SUBJECT: Forwards response to NRC 831220 request for addl info re:  
 TMI Item II.F.2, "Instrumentation for Detection of Inadequate  
 Core Cooling."

Subject: Palo Verde Nuclear Generating Station (PVNGS)  
Units 1, 2 and 3  
Docket Nos. STN-50-528/529/530  
File: 84-056-026; G.1.01.10

APS RESPONSE TO THE NRC  
REQUEST FOR ADDITIONAL INFORMATION ON TMI-2  
TASK ACTION PLAN II.F.2 FOR PALO VERDE  
NUCLEAR GENERATING STATION  
UNITS 1, 2, AND 3

\* POSSIBLE IMPLEMENTATION IN FUTURE  
DATA ACQUISITION AND DISPLAY SYSTEM  
BLOCK DIAGRAM  
Figure SD-1

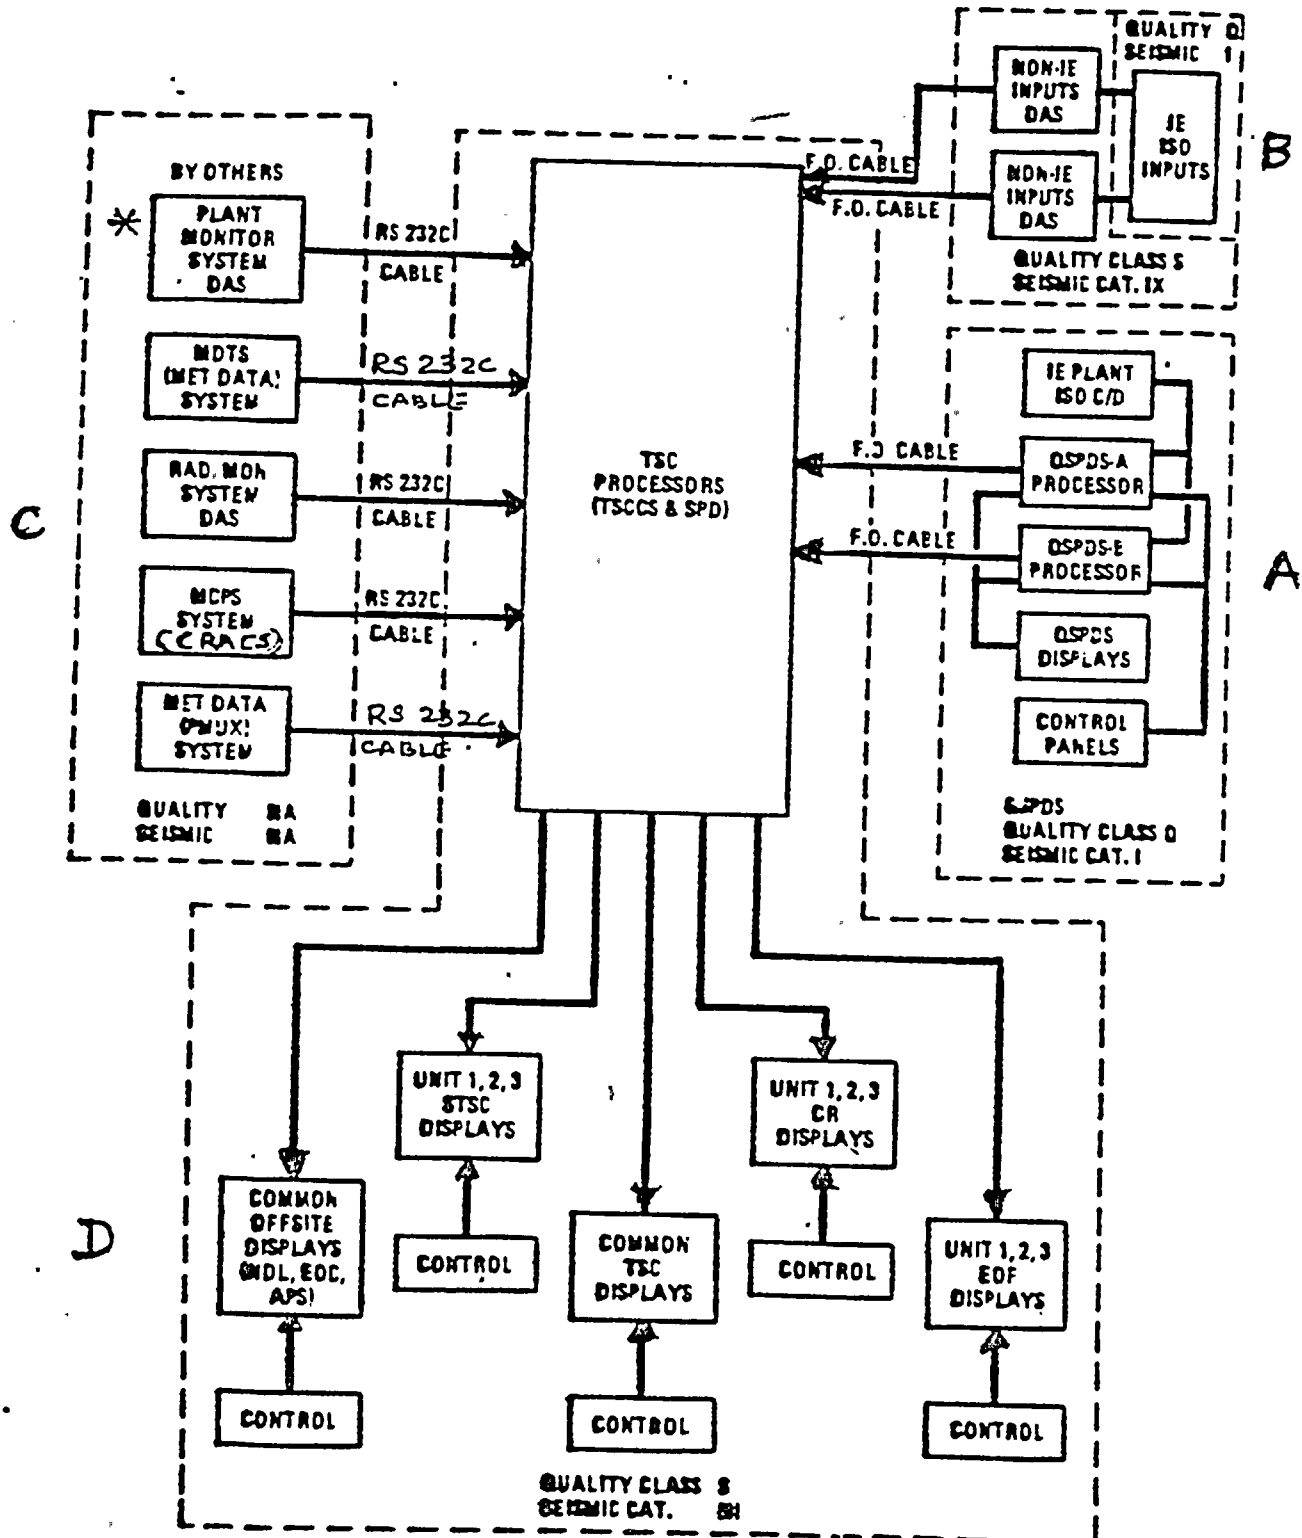
QUESTION: 1. Provide a functional and design description of the Emergency Response Facility Data Acquisition and Display System (ERFDADS) relative to the function and design of the Critical Function Monitoring System (CFMS) described in the CESSAR-80 submittal.

ERFDADS is a Non-Class IE System, very similar to CFMS, that provides all the above mentioned information. Figure (1) shows the block diagram of the ERFDADS System.

ERFDADS / OSPDS CONFIGURATION

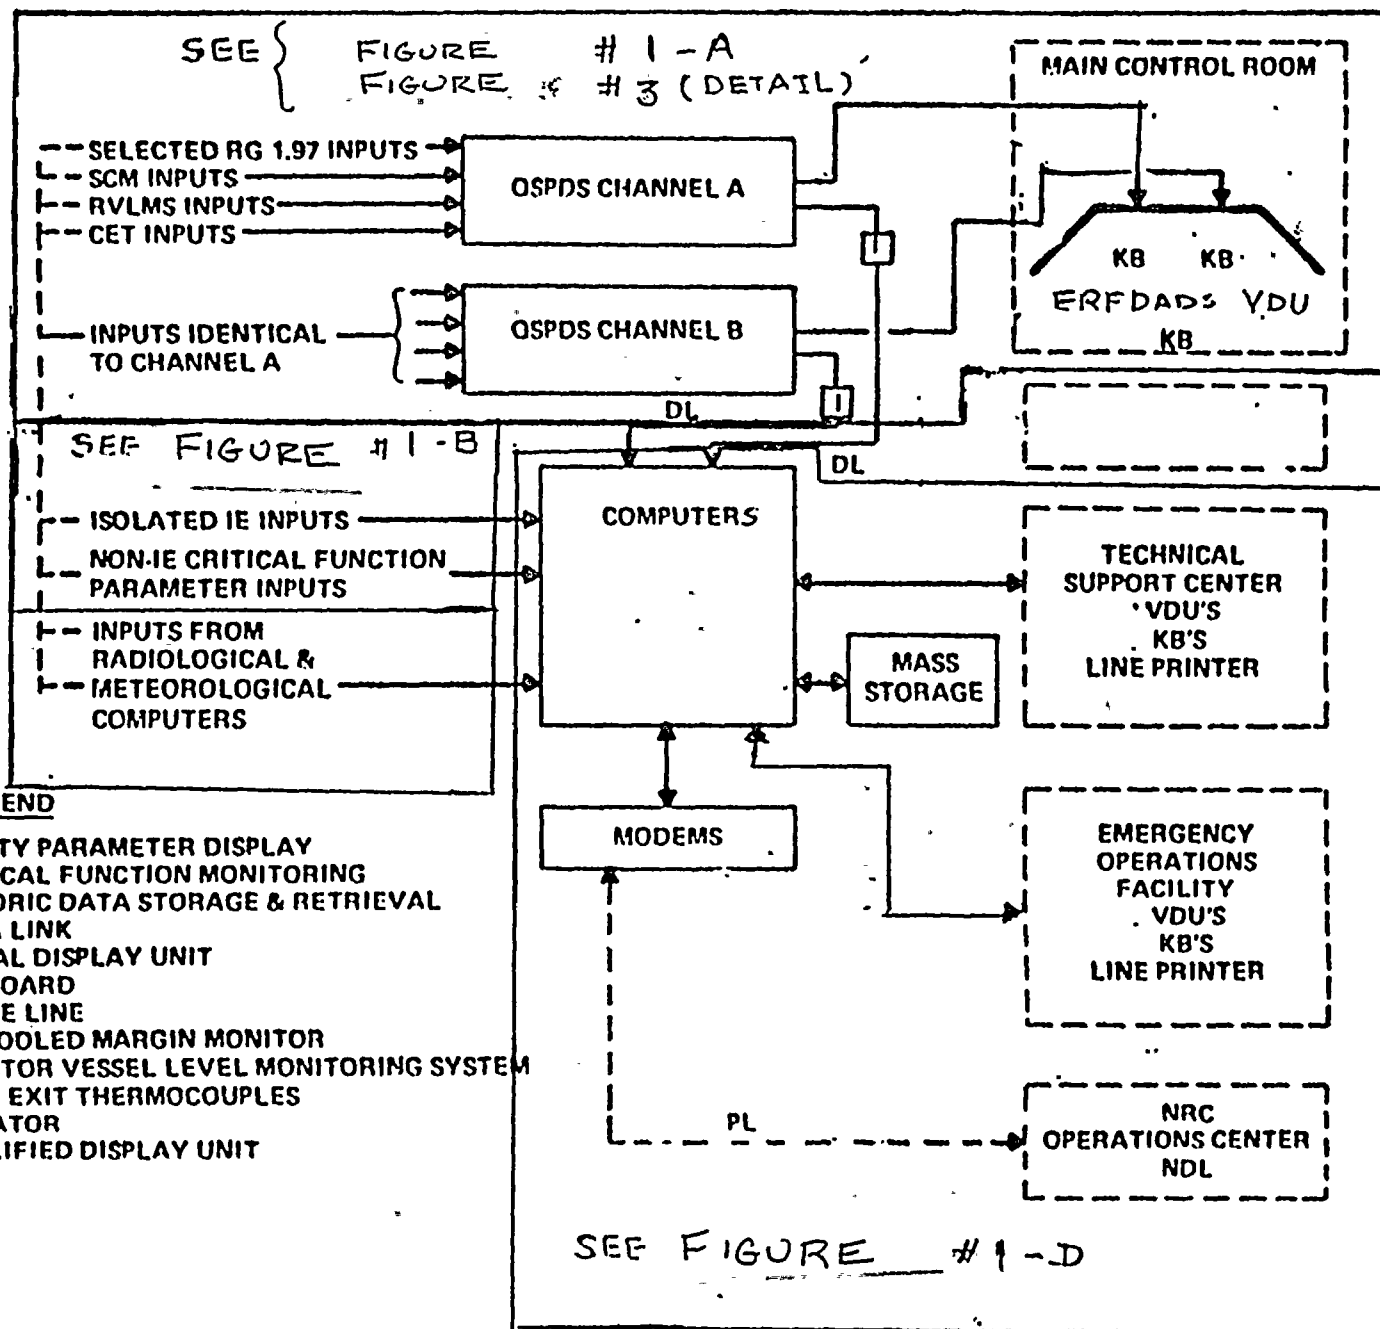
QUESTION 2. Provide a figure to show the Accident Monitoring System (AMS) including all of the components of the final Inadequate Core Cooling Instrumentation (ICCI) System which will clearly identify the primary and backup display system for Core Exit Thermocouples (CETs) and the location of the ICCI display system in the control room. Describe any deviation from the standard CESSAR-80 system design.

The ERFDADS man/machine interface includes one color-graphic CRT per unit in the Control Room, three color-graphic CRT's per unit and two line printers, one for demand and one dedicated for alarms, in the TSC and two color-graphic CRT's per unit and a line printer in the EOF. A simplified configuration diagram for ERFDADS and the QSPDS is shown in Figure (2).

FIGURE - 6  
RVLMS Locations

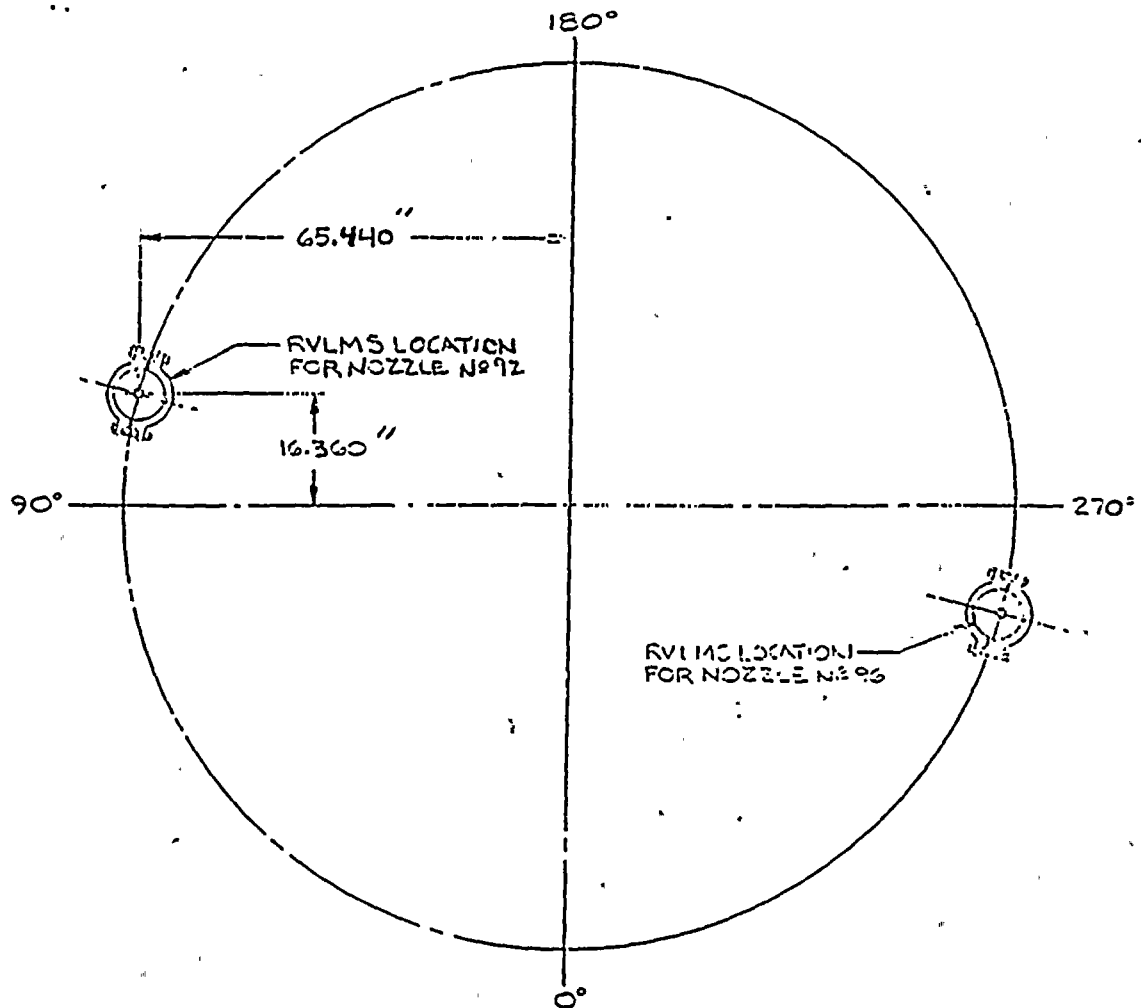
QUESTION 3. Describe locations of the Heated Junction Thermocouple (HJTC) sensors in the reactor vessel and identify any deviation from the standard CESSAR-80 system design.

RESPONSE: The HJTC design incorporates two separate probe assemblies which enter the reactor vessel through the two Reactor Vessel Level Monitoring System (RVLMS) nozzles located on the top of the reactor vessel head as shown in Figure (6).
